## Stage 1 Quality Audit

(Incorporating a DMURS Street Design Audit, and Audits of Accessibility, Cycling, Walking and Road Safety)

<b>Project Title</b>	Proposed Residential Development at Forbes Lane, Dublin
<b>Project No.</b>	24050-07
<b>Client</b>	Malone O'Regan
<b>Document Title</b>	Stage 1 Quality Audit
<b>Document No.</b>	24050-07-001

Figure 5.1 – Raised Crossings without drainage detail

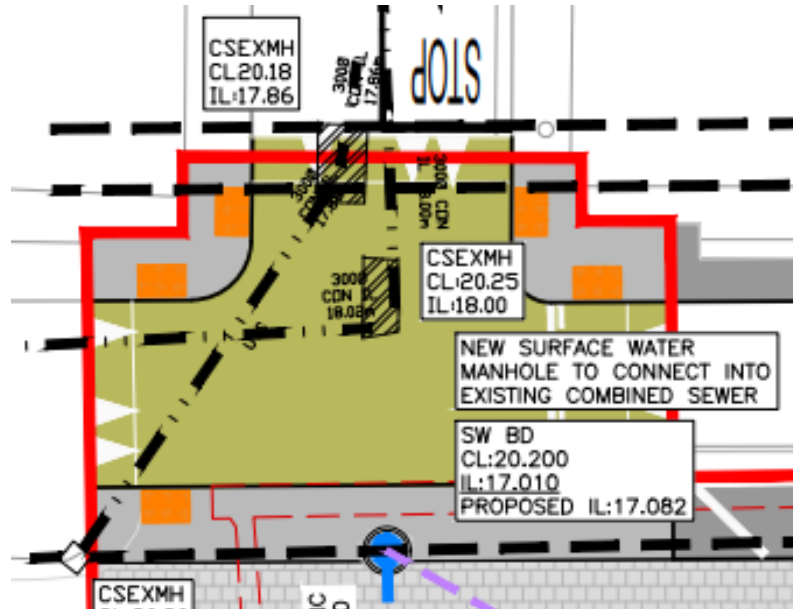
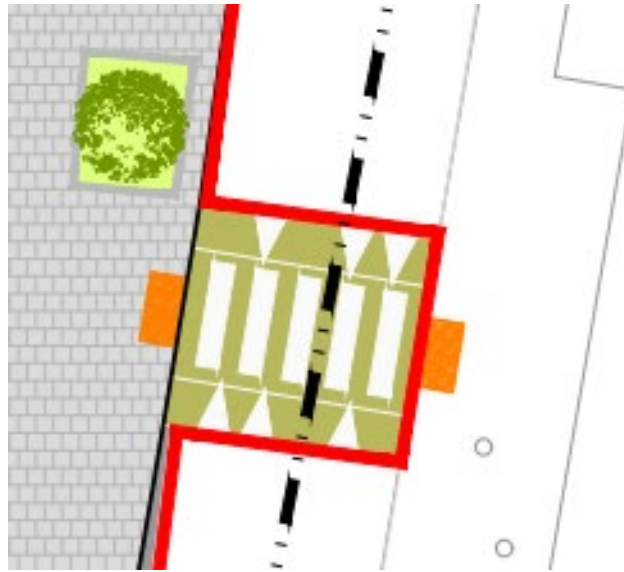
It is noted that the proposed raised tables and grade changes throughout the development (Figure 5.1 to Figure 5.3), do not feature drainage measures on all sides of continuous ramps. This lack of drainage may result in ponding water, and/or associated silt forming, which may result in cyclists slipping and falling onto the road with associated injuries.

Ensure that adequate drainage measures are included for all such grade changes throughout the development.

Figure 5.4 – Visibility Splay potentially interrupted by landscaping

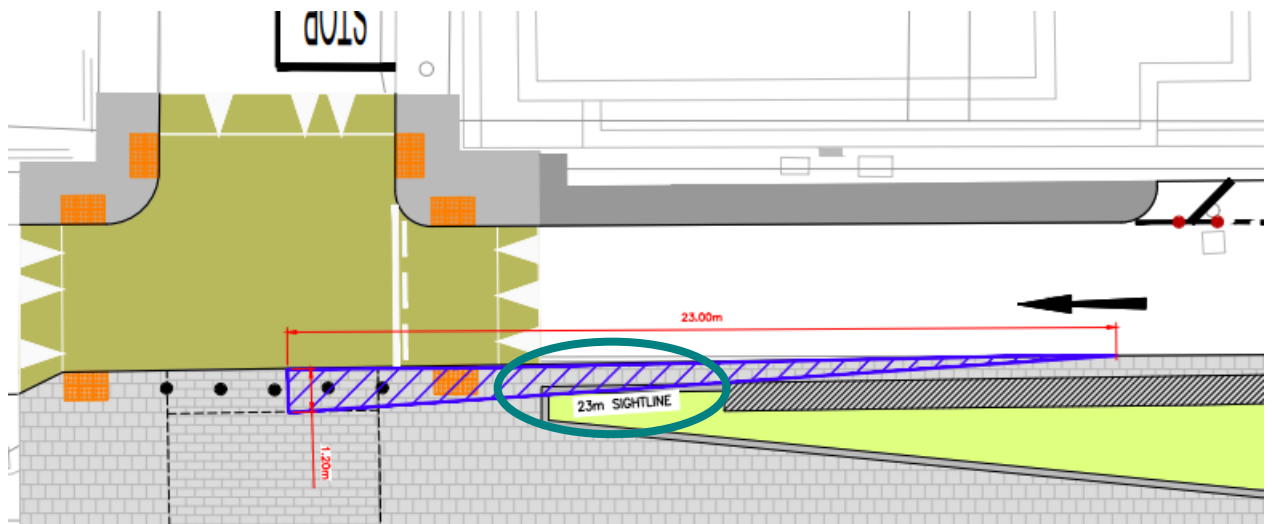
Sightlines at the priority junctions in Figure 5.4 and 5.5 may be impacted by planting in the landscaped areas. This may increase the likelihood of vehicle collisions due to the reduced sightlines.

Ensure adequate visibility splays at all junctions from edge of carriageway.

Figure 5.6 – Sign Clutter

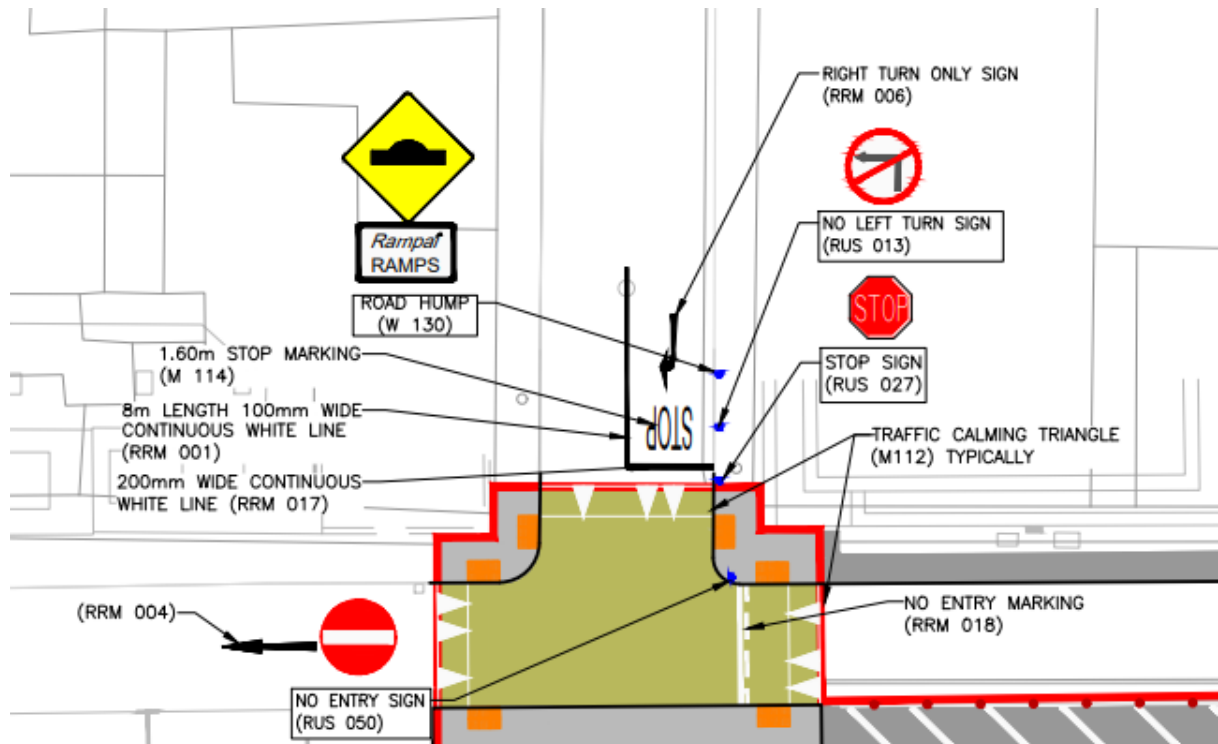
It is proposed to erect three signs in close proximity to one another on Pim Street approach to its junction with Forbes Lane. It is likely that the Ramps sign may obscure visibility of the No Left Turn sign while both may obscure visibility of the Stop sign. A lack of adequate visibility of signage may increase collision risk.

Ensure that adequate visibility is provided to each sign.

Figure 5.7 – Position of Signage

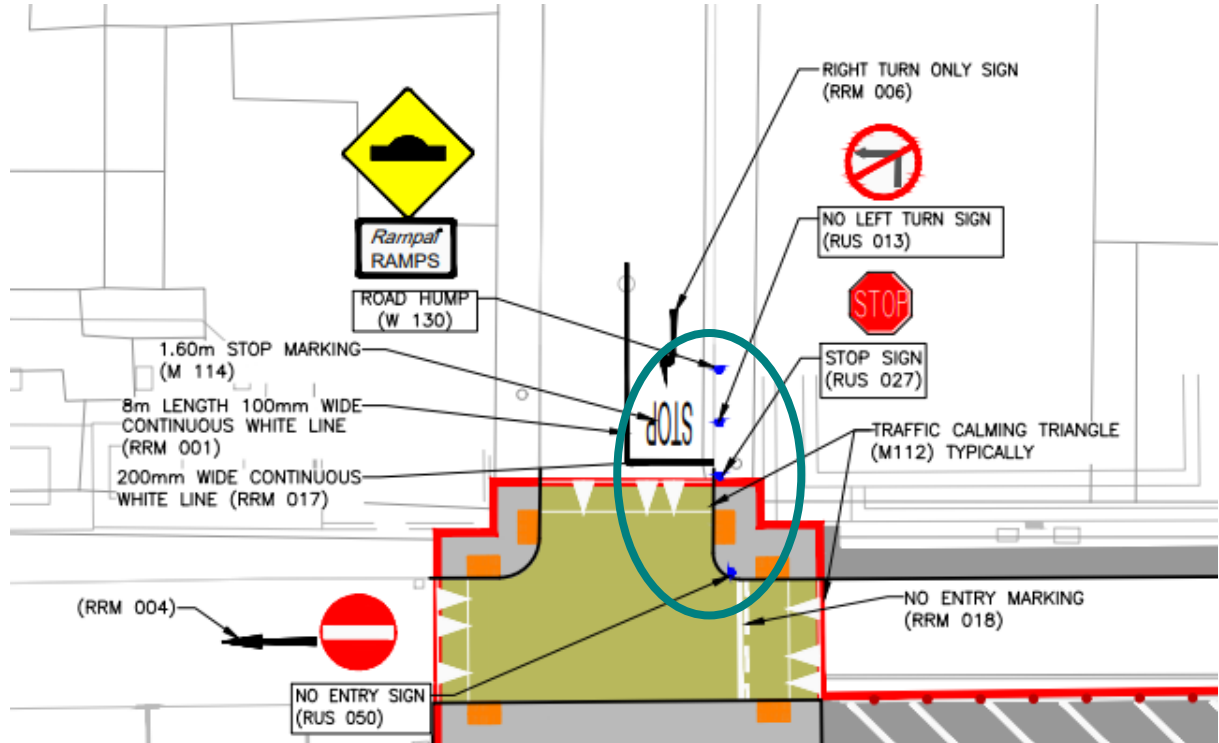
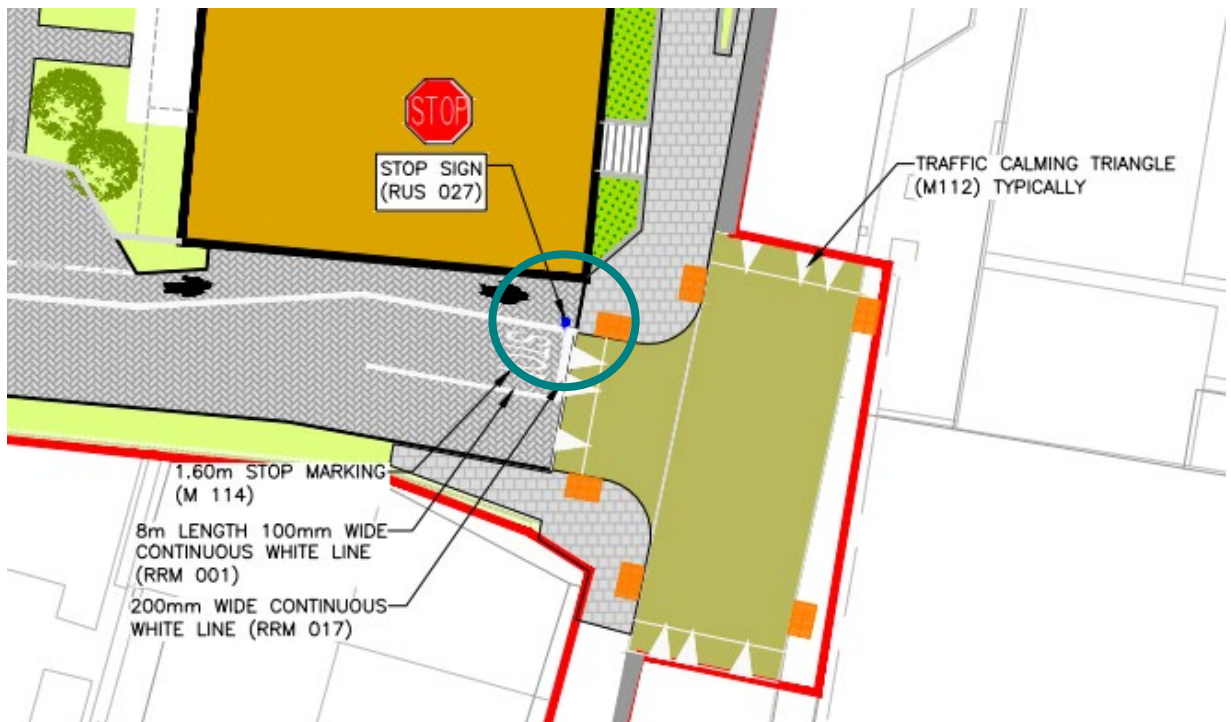
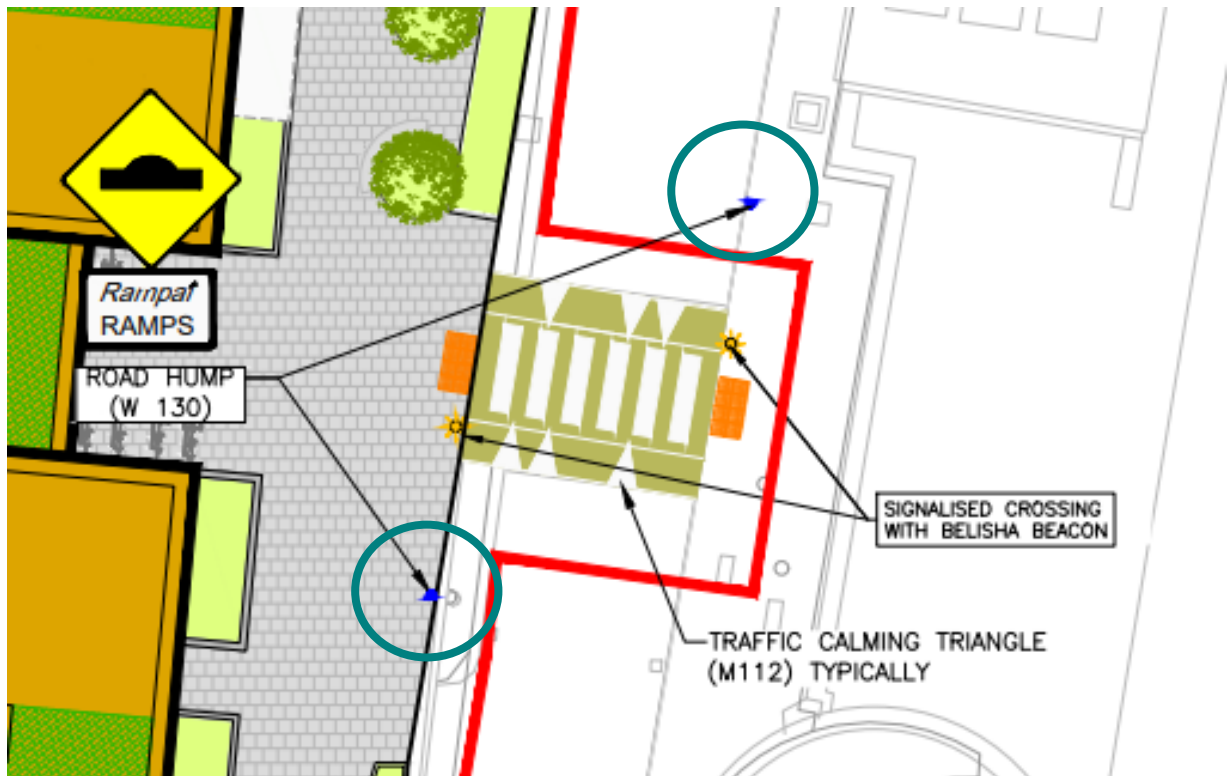
A number of signs appear to be located close to the carriageway edge where they would be at risk of being struck by a passing vehicle. Moving these signs further into the footpaths may also reduce the effective footpath width in particular for mobility impaired pedestrians.

Ensure that any proposed signage is located so as to avoid being struck by passing vehicles and does not reduce the effective footpath width in particular for mobility impaired pedestrians.

*Figure 6.2 – Proposed pedestrian crossing*

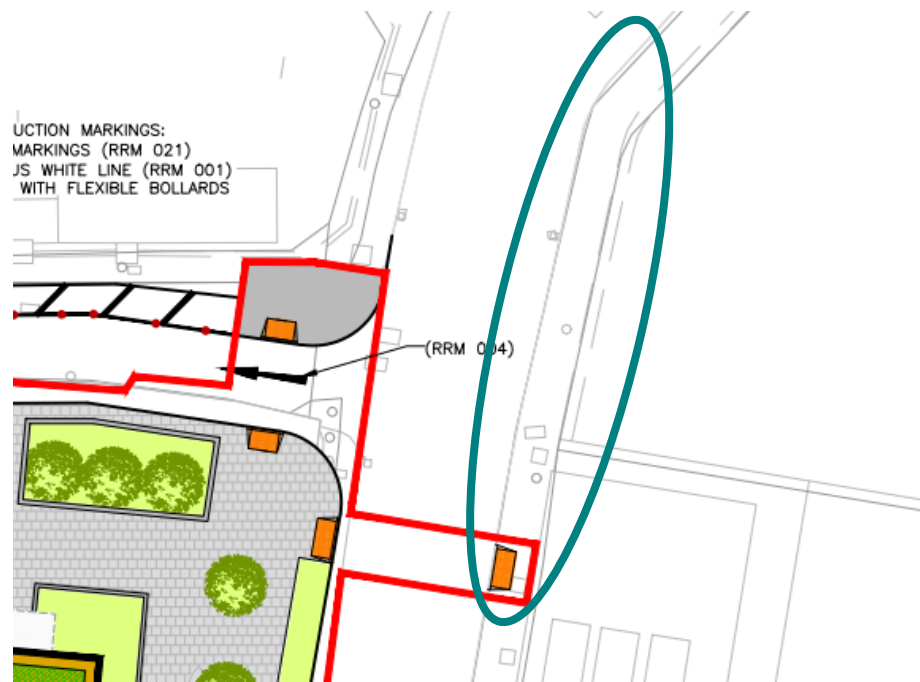
Intervisibility between pedestrians crossing the proposed crossing on Marrowbone Lane and approaching southbound vehicles may be restricted by the existing boundary wall and railings on the east side of the carriageway (Figure 6.3). A lack of adequate intervisibility may increase the likelihood of pedestrians being struck by approaching vehicles at this crossing.

Ensure adequate intervisibility is provided between pedestrians crossing at the pedestrian crossing and approaching southbound vehicles.

*Figure 6.4 – Pedestrian Intervisibility*

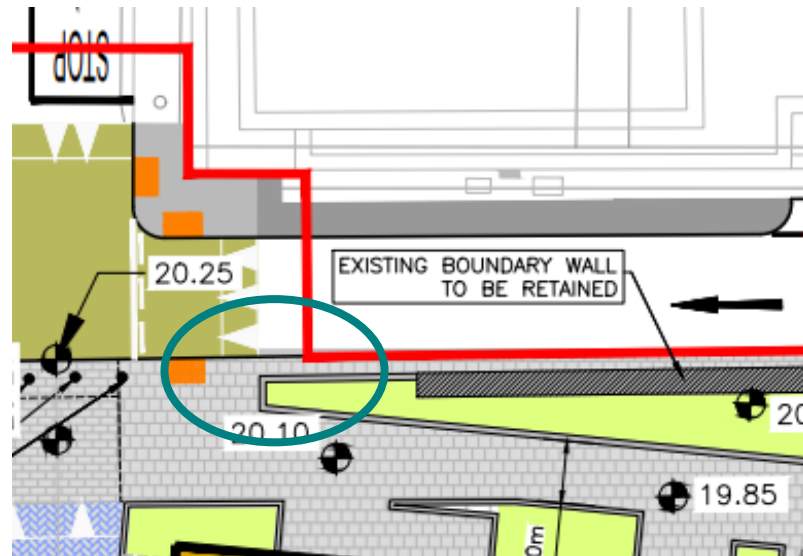
Landscaping is proposed to the east of the pedestrian crossing on Forbes Lane. It is unclear as to the heights of landscaping proposed in this area. Intervisibility between pedestrians crossing at this location and approaching westbound vehicles may be restricted by high planting within the landscaped area. A lack of adequate intervisibility may increase the likelihood of pedestrians being struck by approaching vehicles at this crossing.

Ensure adequate intervisibility is provided between pedestrians crossing at the pedestrian crossing and approaching westbound vehicles. Revise the landscaping area if necessary.

**Figure 7.1** – GDA Cycle Network ([www.nationaltransport.ie/wp-content/uploads/2023/01/2022-GDA-Cycle-Network.pdf](http://www.nationaltransport.ie/wp-content/uploads/2023/01/2022-GDA-Cycle-Network.pdf))

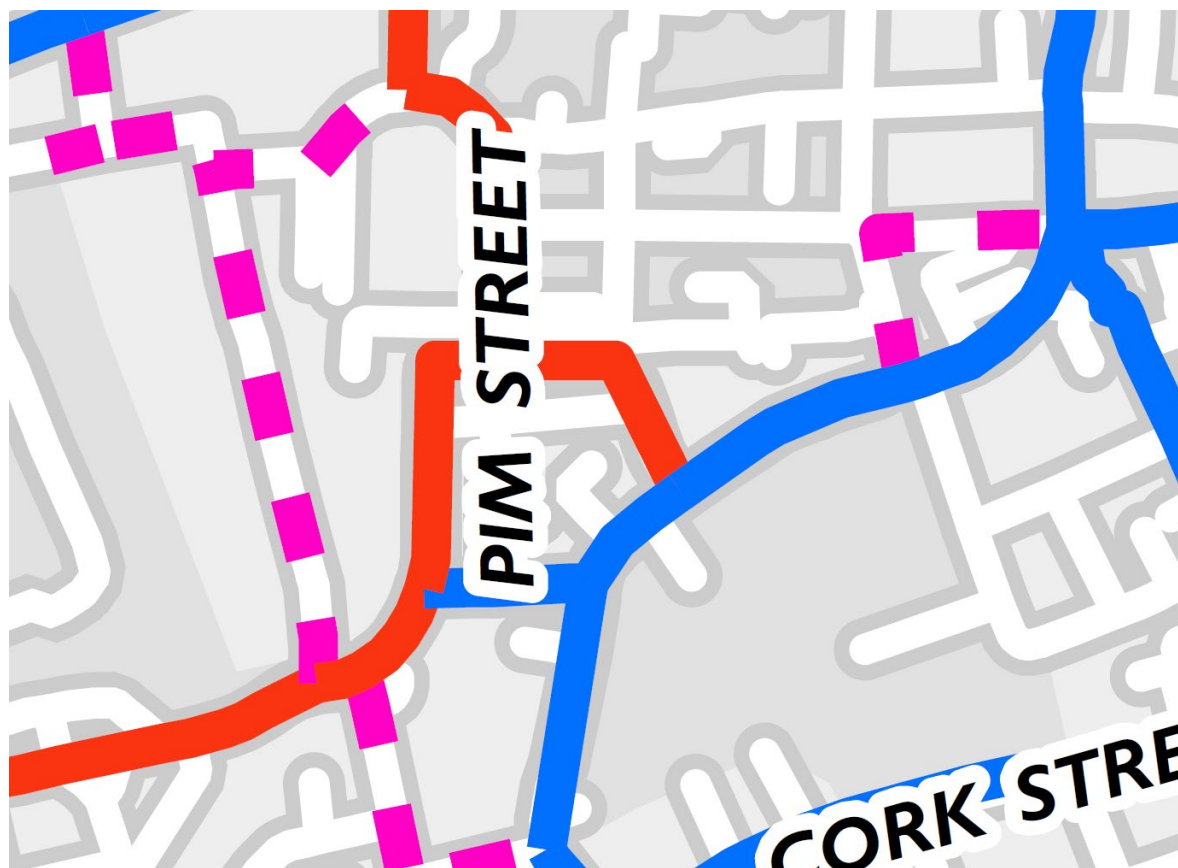
While there is no proposed cycle infrastructure in the development, it is not clear however how the development will tie into the proposed 'Primary Orbital' Cycle Route (red in Figure 7.1) along James Walk, the 'Secondary' Route (blue in Figure 7.1) on Marrowbone Lane, or the 'Feeder' Route (dashed pink line in Figure 7.1) on Basin View. A lack of coordination may reduce the effectiveness of these schemes, proposed by Dublin City Council and National Transport Authority, and undermine potential to achieve cyclist desire lines.

Consider wider network impacts of future schemes to support a network of segregated cycleways through the development. Consult with Dublin City Council Active Travel to ensure the development is futureproofed.

Figure 8.1 – Pedestrian Steps

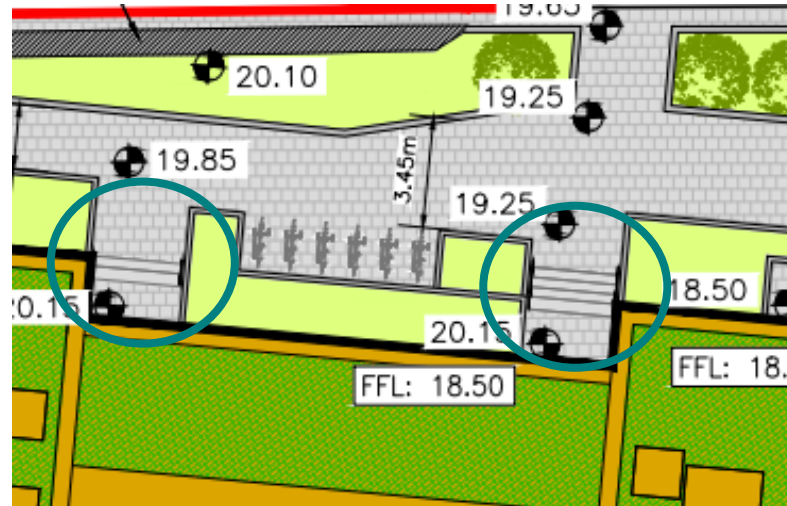
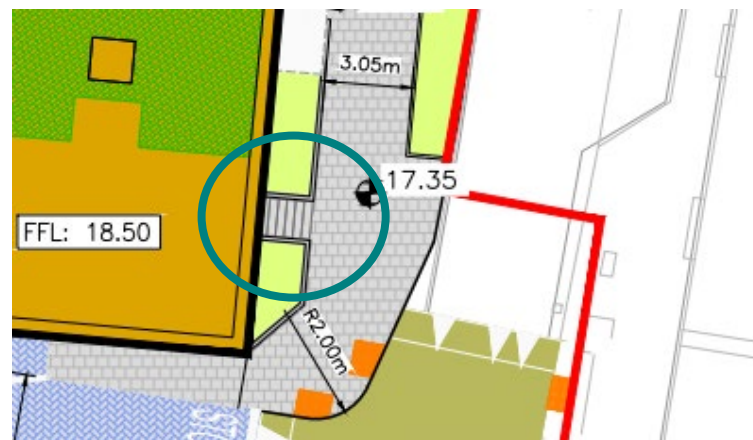
Sets of steps in the development do not feature tactile paving. It is unclear if proposed steps feature railings. Lack of railings and tactile paving may increase the likelihood of injuries for pedestrians with mobility impairments or vision impairments respectively.

Ensure all steps throughout the development feature railings and appropriate tactile paving.

**Figure 8.3 – Interrupted Tactile Paving**

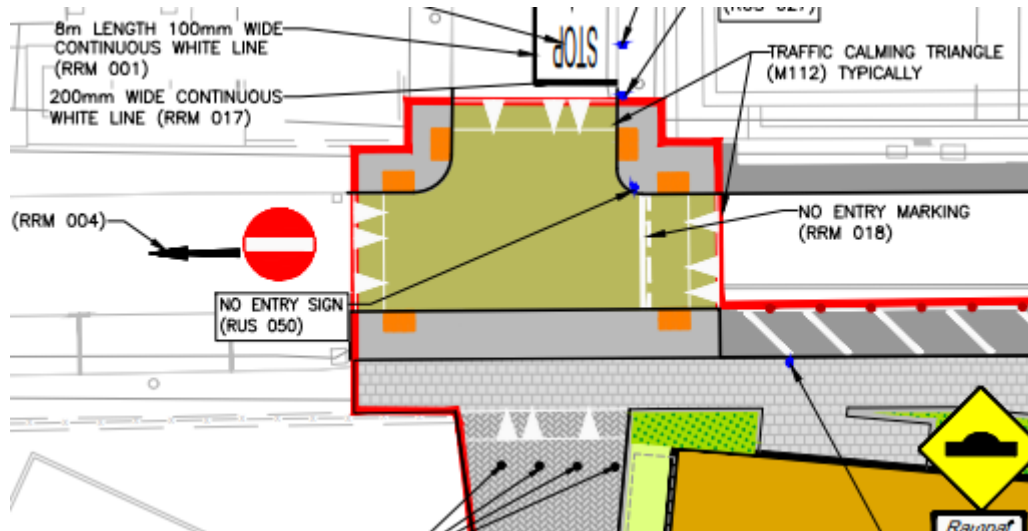
Some Existing Tactile Paving at the junction location in Figure 8.3 is interrupted by chamber lids (Figure 8.4). This may result in user confusion for pedestrians with vision impairments.

Relocate all chamber lids away from tactile paving locations or use recessed drainage lids.
